SUNDRY NOTICES AND REPORTS ON WELLS
Do not use this form for proposals to drill or to re-enter an abandoned well. Use form 3160-3 (APD) for such proposals.

HILCORP ENERGY COMPANY
SAN JUAN 32-9 UNIT 95R
NOTICE OF INTENT TO PERMANENTLY ABANDON

Hilcorp Energy Company
Plug & Abandon Procedure
January 9, 2020

CONDITIONS OF APPROVAL

SJ 32-9 Unit #95R
API: 30-045-24875
San Juan County
Blanco Pictured Cliffs
Proposed P&A WBD

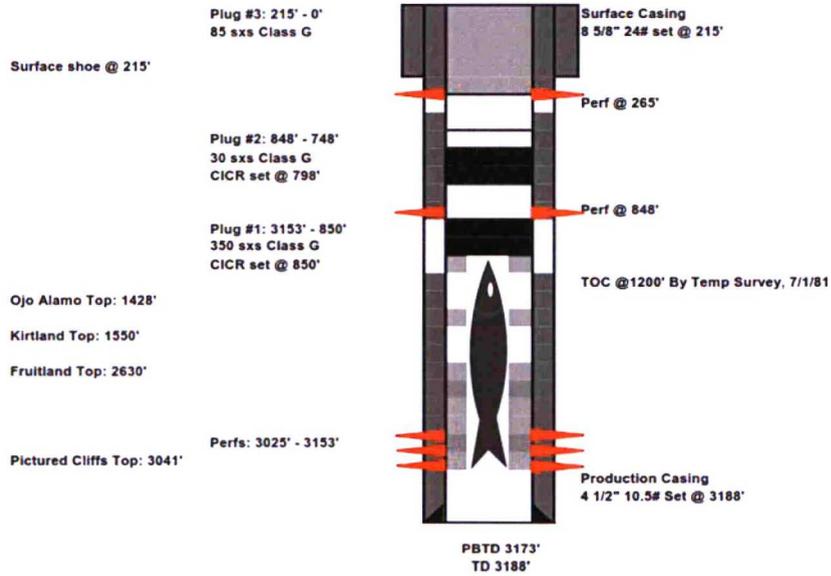
- Please ensure that the tops of the Pictured Cliffs, Fruitland, and Nacimiento formations as well as the entire Ojo Alamo aquifer, identified in this report, are isolated by proper placement of cement plugs. This will protect the freshwater sands in this well bore.

1. Plugging operations authorized are subject to the attached "General Requirements for Permanent Abandonment of Wells on Federal and Indian Lease."
2. Farmington Office is to be notified at least 24 hours before the plugging operations commence (505) 564-7750.
3. Plug 2: Increase volume of outside plug to 40 sacks including the 100% excess for a total plug of 52 sacks.
